**BEFORE THE INDEPENDENT HEARING PANEL
APPOINTED BY HAMILTON CITY COUNCIL**

IN THE MATTER of hearing submissions on Plan Change 5 to the
Hamilton City District Plan

**SUBMITTER STATEMENT OF
LYNNE SUN ON BEHALF OF THE
SHORTBREAD LIMITED**

22 SEPTEMBER 2022

Figure 1: Structure Plan Excerpt

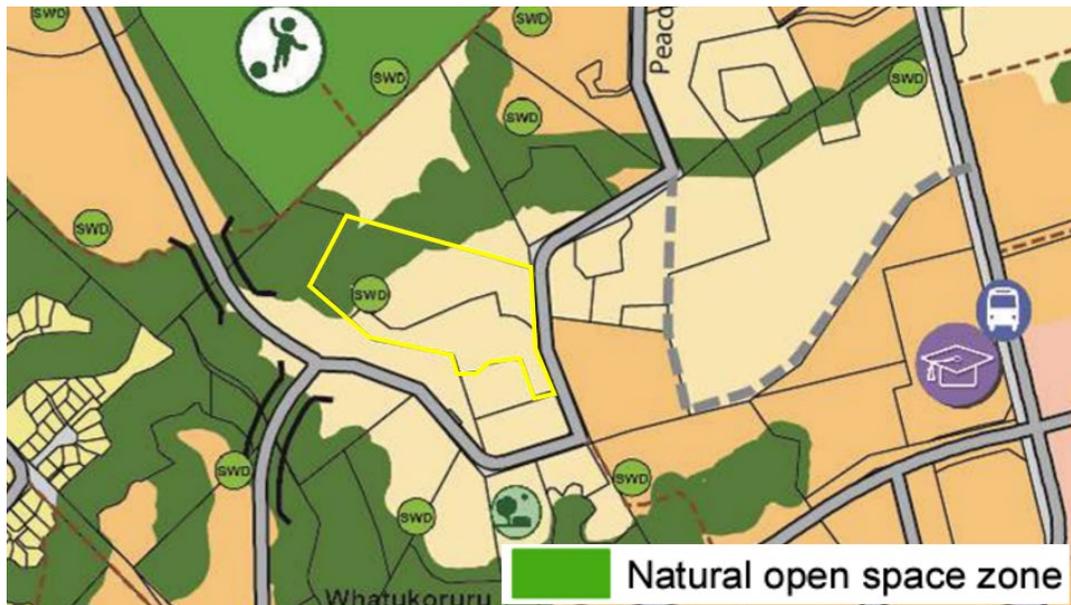
10 As showed on the Appendix 2 Structure Plans and Figure 1 below, the application site is partially contained within the NOSZ.

- 11 Points 7.53 and 7.55 of the S42a Report indicated that all subdivision applications within the Peacocke Structure Plan adjoining or including any open space zone or involving more than 5,000m² of land shall include, as part of the resource consent application, an ERMP and BMP.
- 12 The submitters' concern relates to the affordability, effectiveness, and consistency to undertake these ecological management plans on a 'site-to-site' basis through individual resource consent.

Different ecologists might come up with various methodologies and means to enhance the SBHAs. This will later on create inconsistency in implementation among properties.

The costs to engage a qualified ecologist and produce these ecological management plans are very high which in turn, impact housing affordability.

In the Submitter's opinion, a master ecological management plan should be produced by HCC (potentially in collaboration with Department of Conservation and Waikato Regional Plan) to ensure similar specifications can be adopted by different landowners.

Figure 5: Structure Plan Excerpt

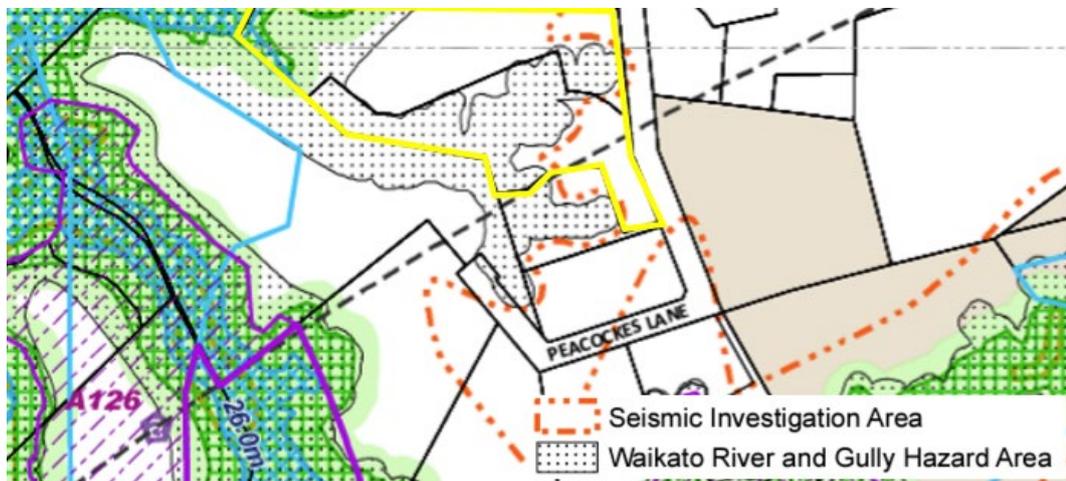
23 As showed on the Appendix 2 Structure Plans and Figure 5 below, the application site contains a section of Seismic Investigation Area.

24 Point 7.128 of the S42A report stated “*The Seismic Setback Lines were identified as an area where further geotechnical investigation would be required due to the sites' proximity to a waterbody or gully, particularly in regard to assessments for foundations of buildings.*”

25 The Submitter considers that the above requirement is superfluous given that a site suitability report (s106 assessment) is sufficient to address potential natural hazards on site.

**CATCHMENT PLAN
PEACOCKES ROAD**

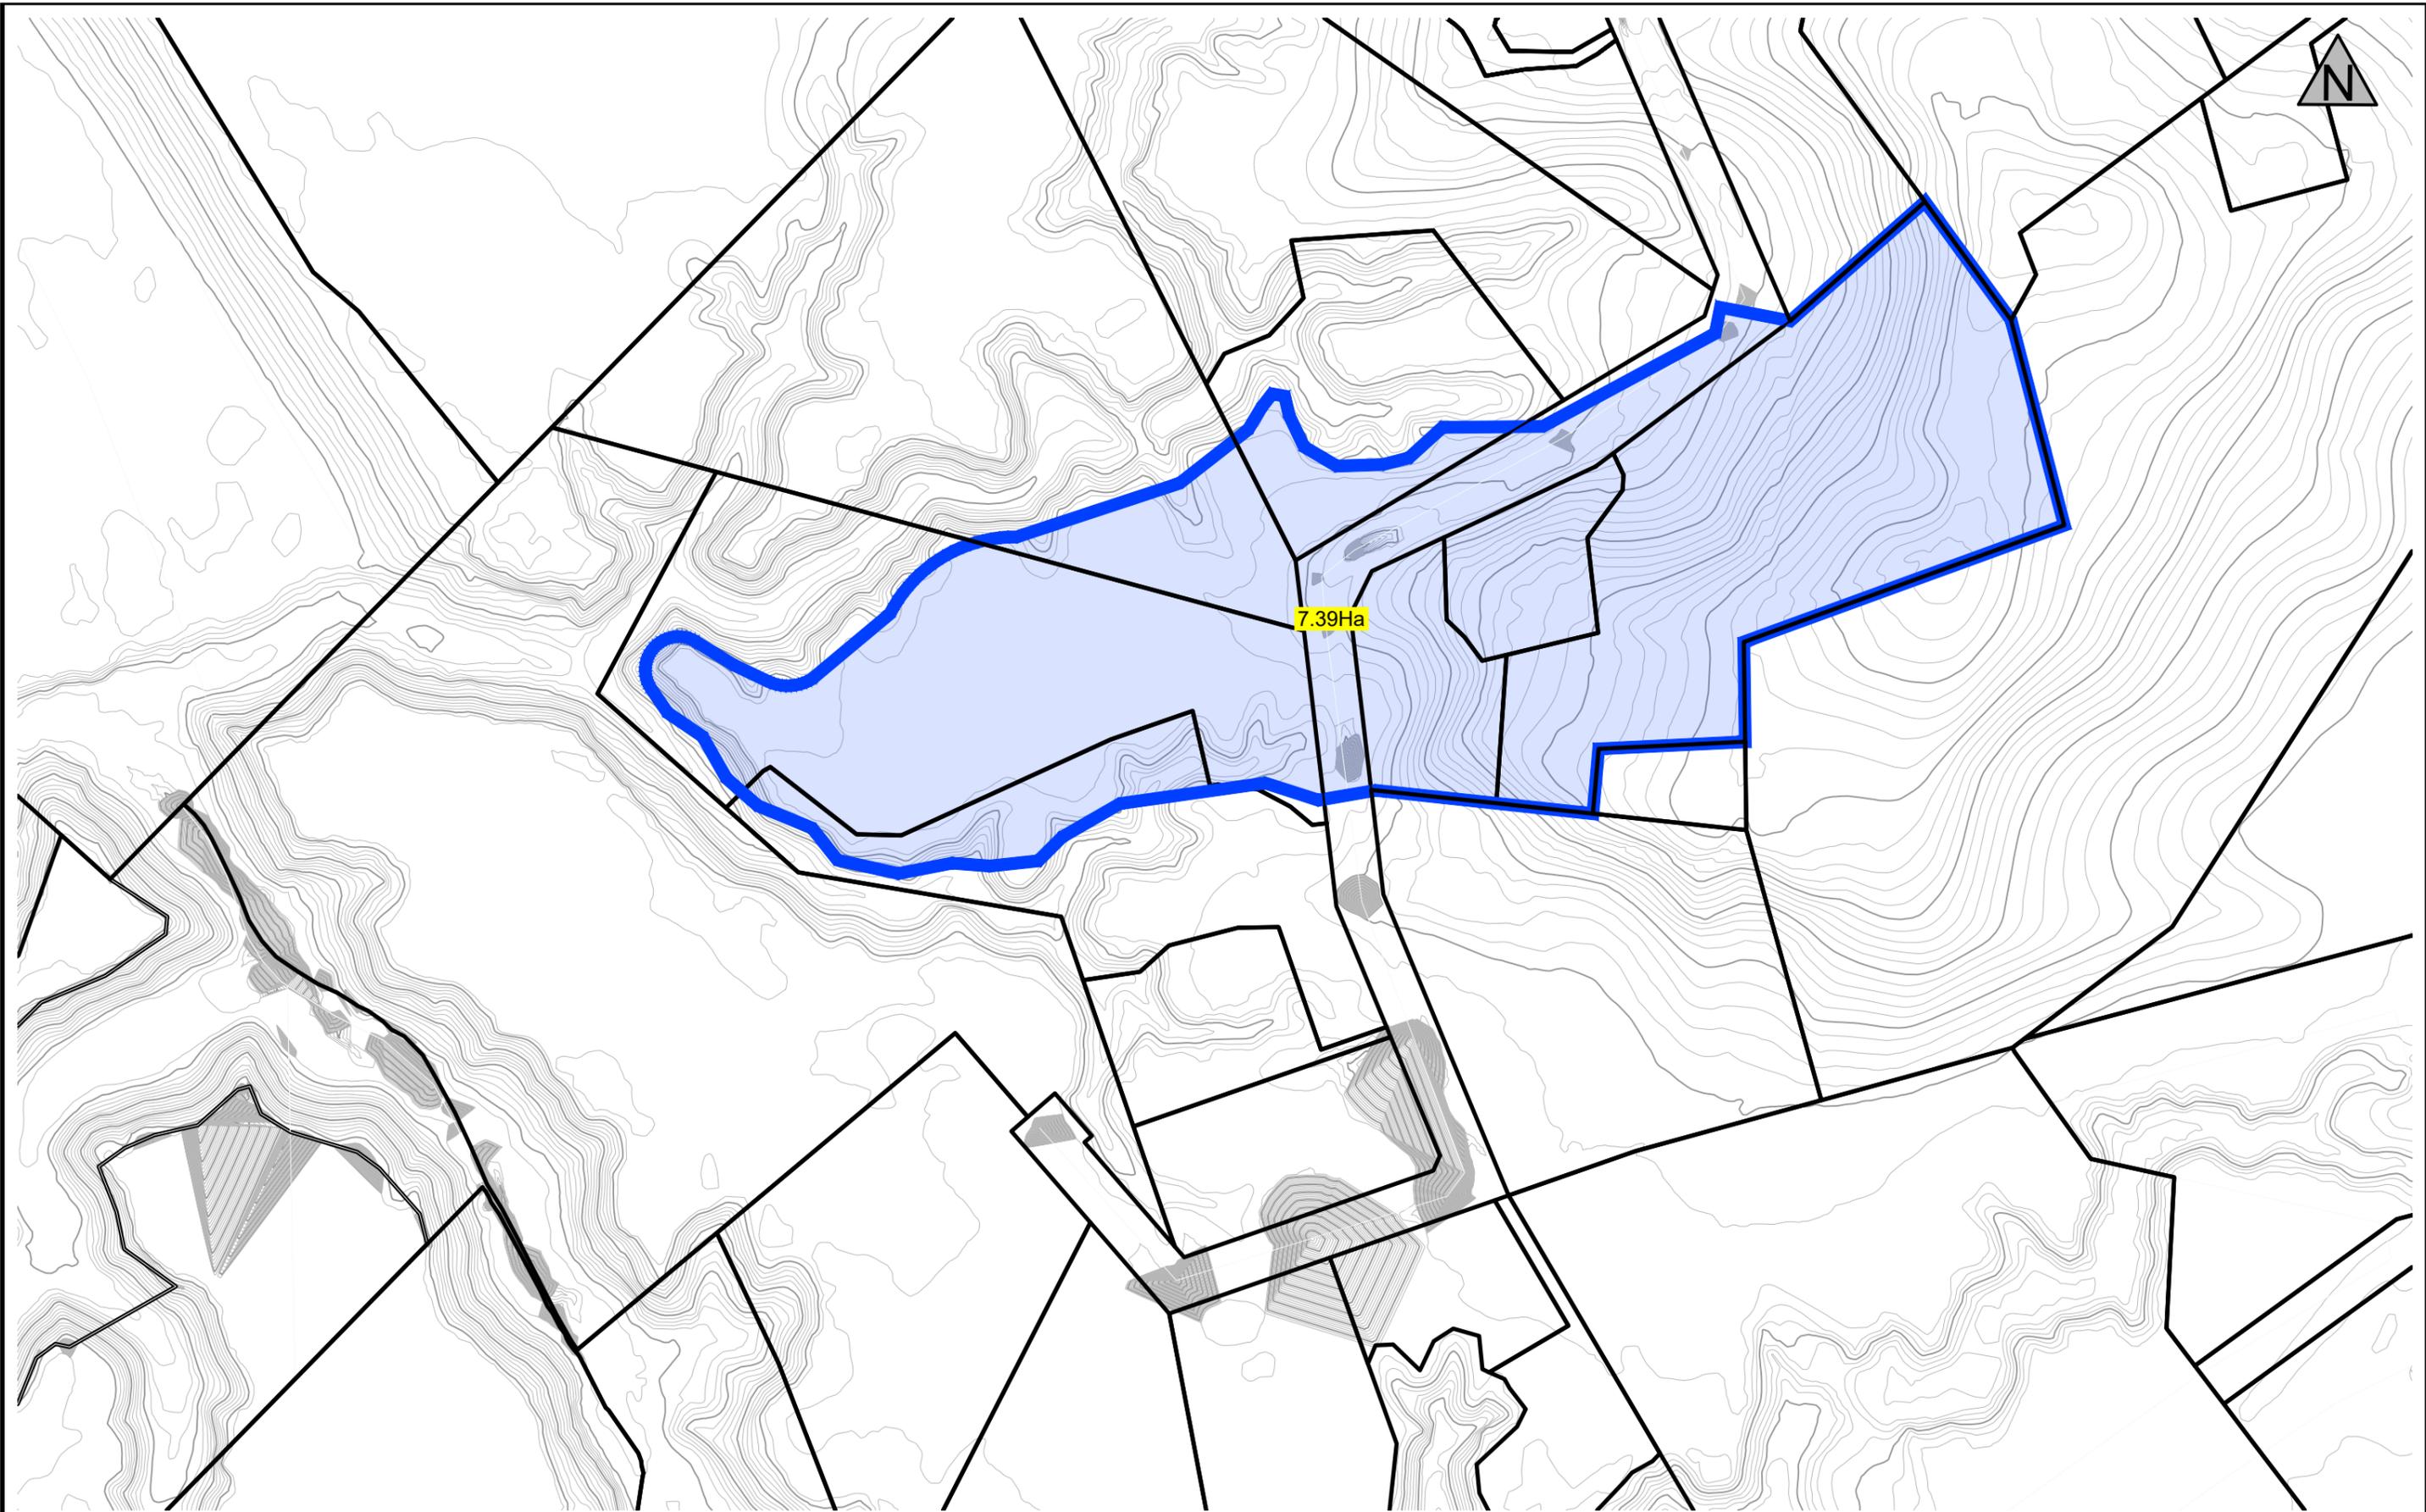
The reason for this document is to provide evidence showing the proposed structure plan Wetland Location for Catchment SC-7 is not suitable in terms of location. A revised location is proposed that will be more suitable in terms of cost and servicing the wider catchment.

The current Draft Structure Plan shows the future wetland for catchment SC-7 to be located along the upper terraces, where ideally residential development should occur. By proposing for this wetland to be located along the upper terraces, there are significant challenges with regards to servicing the entire catchment via a gravity system. The main challenges will be deep infrastructure, excessive earthworks requirements for the wetland and excessive cost in regards gully bank stability and construction cost.

Blue Wallace proposes that the future wetland be located at the head of the southern gully system, please see Figure 1. The landowner has confirmed that the subject gully head area is currently covered by grass and used as paddock and accessible by dairy cow, which holds no significant ecological value. The upper catchment can also be serviced with a shallower gravity system, which results in a significantly lower construction estimate to construct the system and future wetland.

This assessment highlighted that this wetland location is not ideal due to the excessive deep infrastructure that will be required a deep 2-3m gravity system to service the upper catchment. The earthworks required for the construction of the wetland will result in excessive cuts up to +/- 3-4m depth of the for wetland to be able to service the upper catchment. Bank

stability will also be required for the construction of a wetland close to the unstable gully banks which will result in additional construction and design cost.

This location provides a much better outcome with regards to servicing the entire catchment. It provides a much more cost-effective solution as enables much shallower infrastructure +/- 1-1.5m deep and minimum earthworks required for the wetland construction.
